SEMMMS A6 to Manchester Airport Relief Road

Aecom: WCML Crossing Option Comparison
(Over v Under)

1007/6.19/108

June 2012

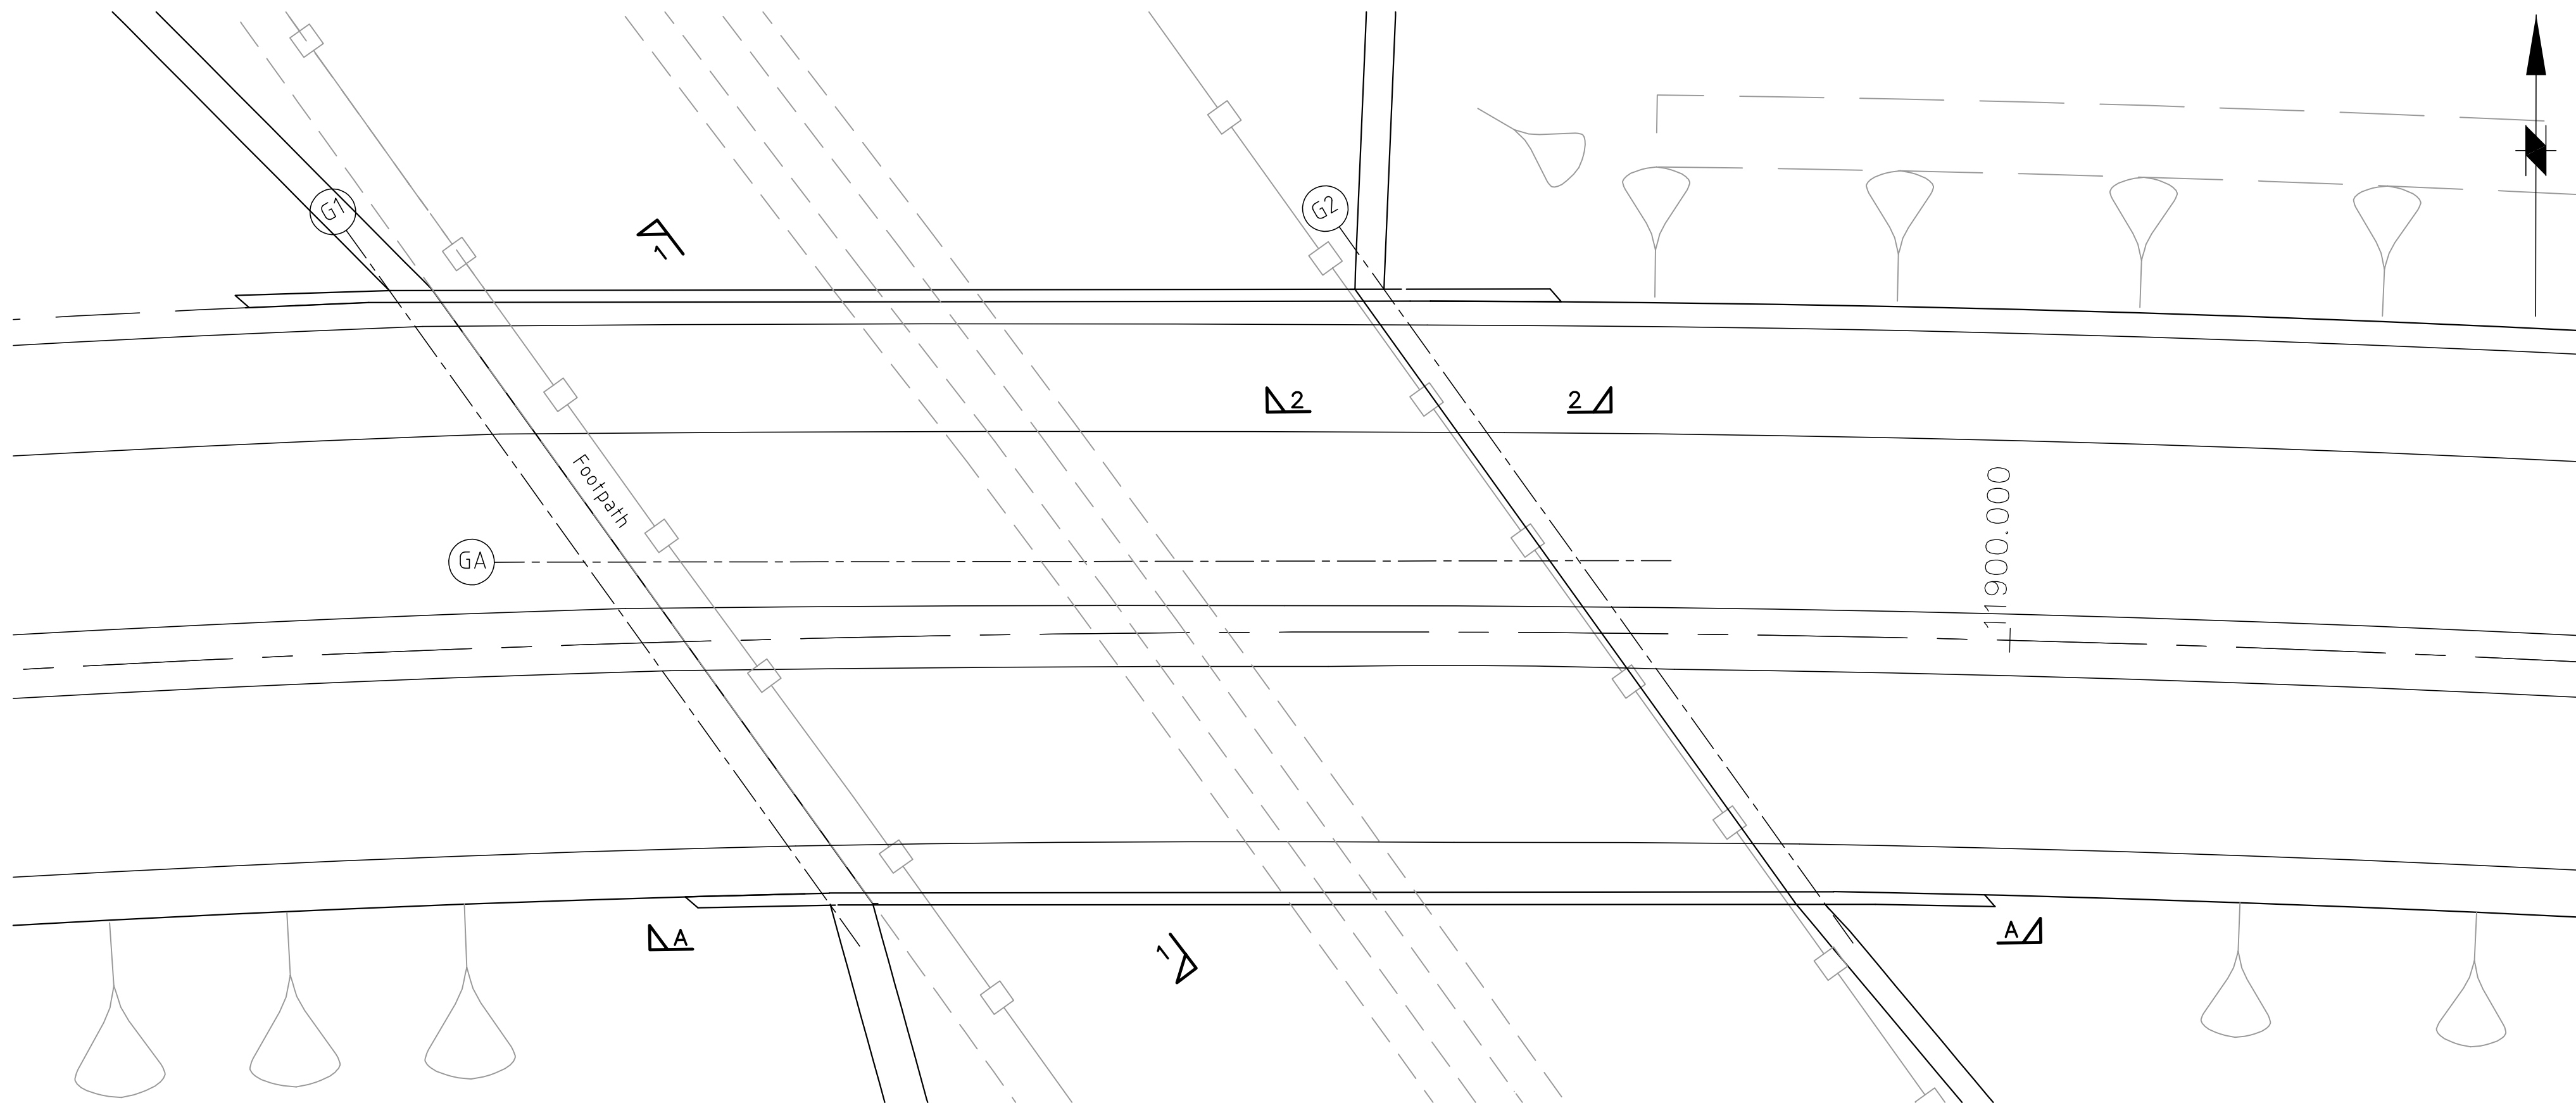
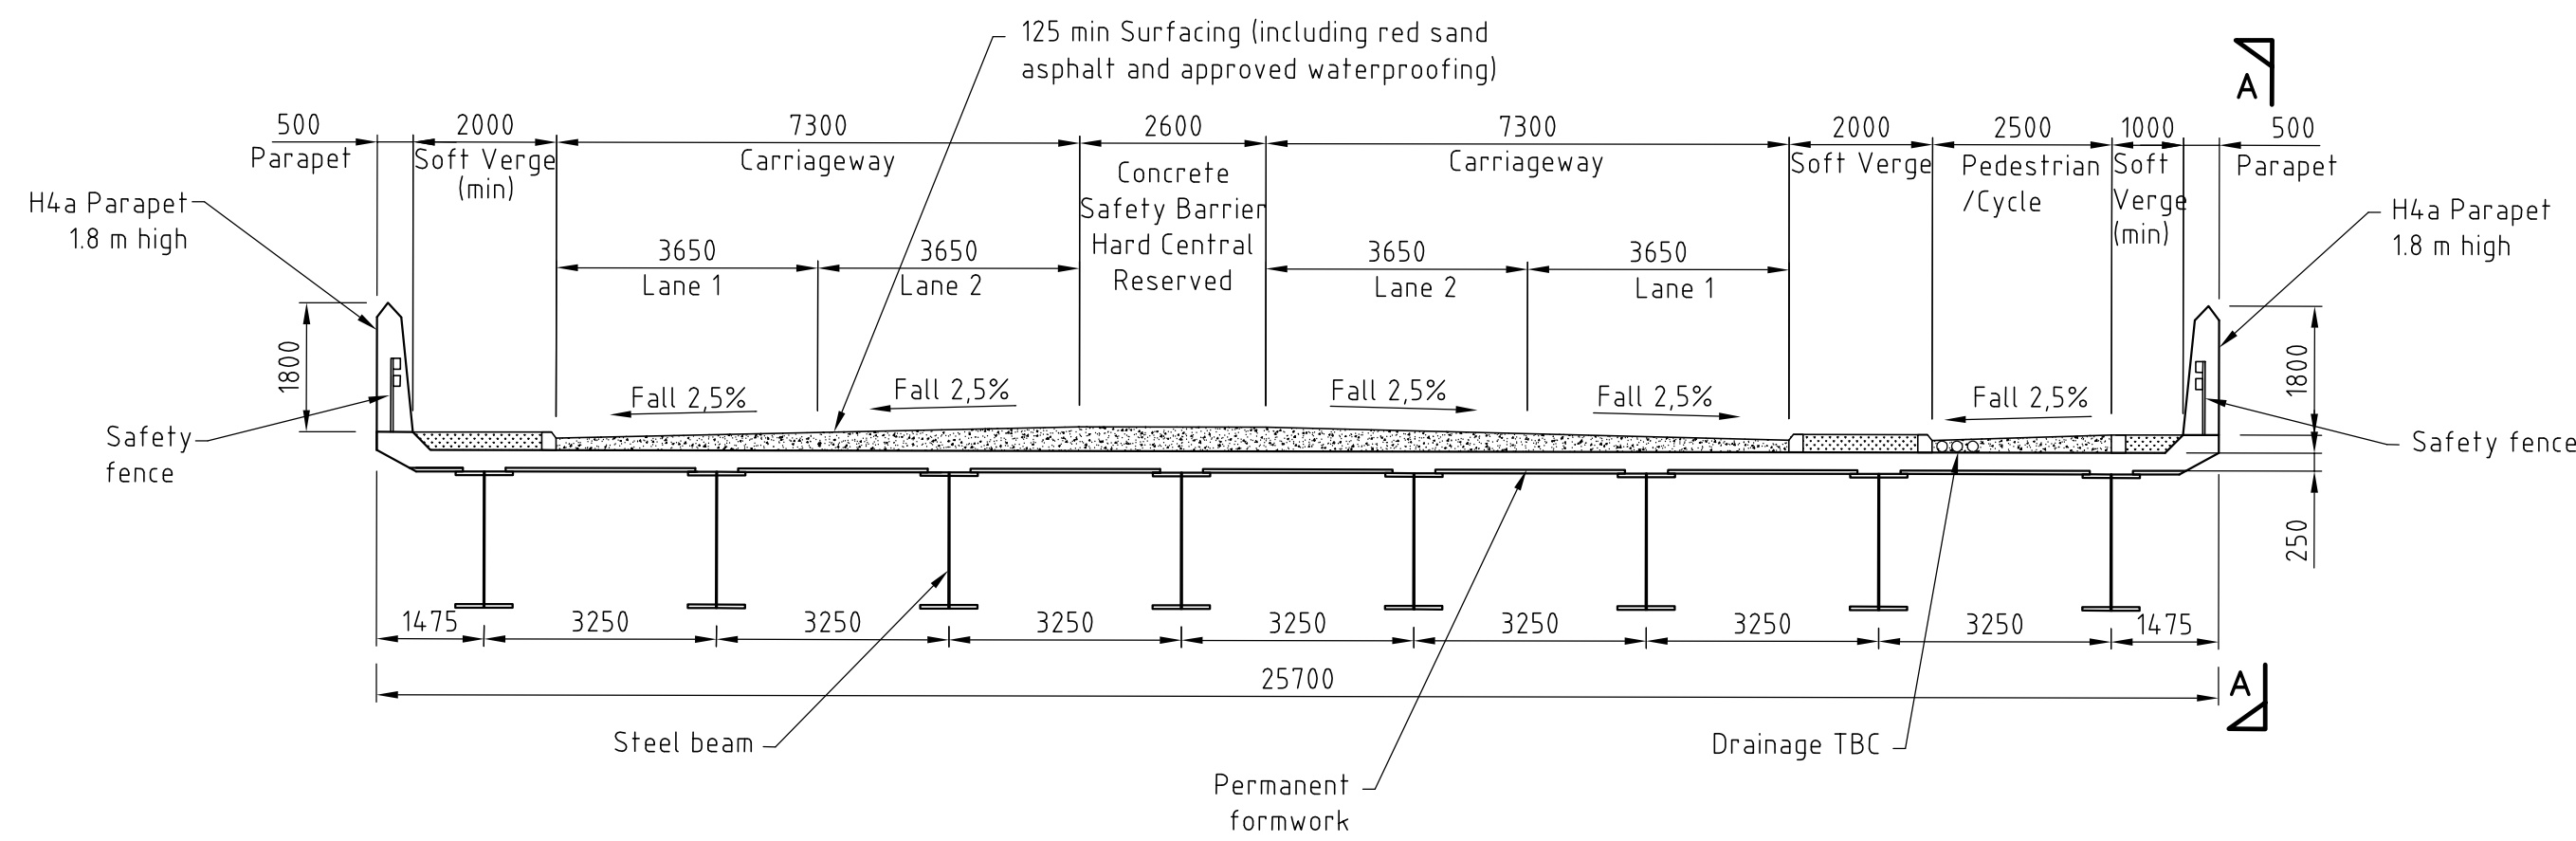
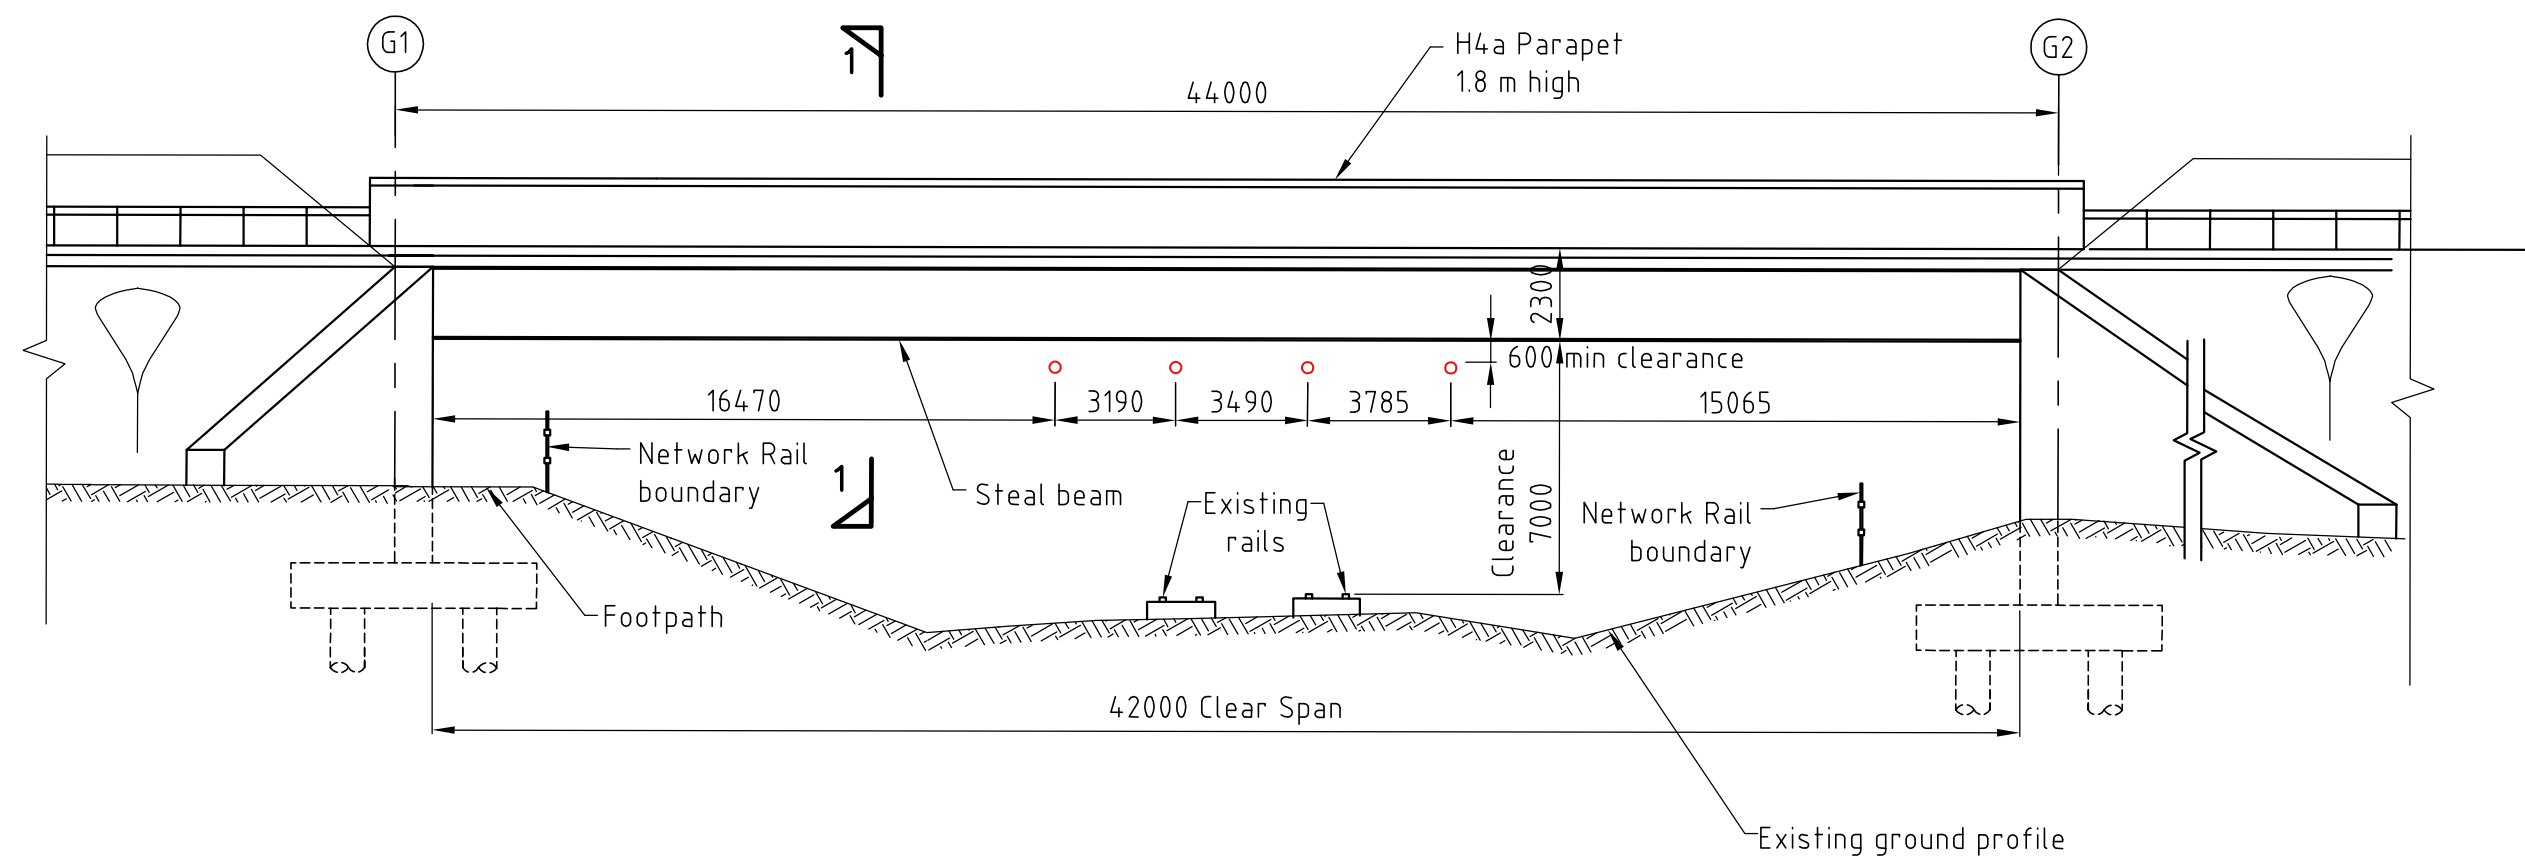
The proposed road over rail bridge as shown on supplied General Arrangement drawing 1007/3D/DF5/A6-MA/B008/708 shows abutments and associated foundations outside of the overall NR rail boundary and therefore all lateral clearances required are satisfied.

A number of possible design options were considered by AECOM in the previous study, and also by Stockport Metropolitan Borough Council. The current proposed design for road over rail structure by Stockport MBC as shown on supplied drawing 1007/3D/DF5/A6-MA/B008/708 is for a composite plate girder made of weathering steel with reinforced concrete slab deck supported on reinforced concrete abutments and piled foundations with splayed wingwalls. The proposed structure is a single span simply supported bridge with semi-integral construction to reduce maintenance problems. The square deck width including the parapet upstands is 25.7m. The skew angle will be approximately 36 degrees.

The single span will be 42.0m measured between abutment faces. This will allow the existing footpath on the west side to remain intact and also allows enough distance on the east side for inspection and possibly replacing the bearings without the need for possession times. This span also allows access for bearing replacements and meets the minimum maintenance requirements for the local authority Stockport MBC. The Council commissioned ND Oliver to carry out a topographic survey at the crossing location and the levels of the OHLEs are known and reflected in the Design Freeze 5 alignment.

It is noted in the supplied preliminary Design Report for this crossing that piles are to be driven. Given the clay ground conditions and proximity of the electrified rail line it is considered that driven piles are not appropriate and that bored piles of similar design will be more appropriate.

The bridge design shown on supplied drawing 1007/3D/DF5/A6-MA/B008/708 is considered appropriate, but consideration should be given to reducing the vertical alignment shown at Design Freeze 5 as there appears to be more clearance over the rail than is necessary.
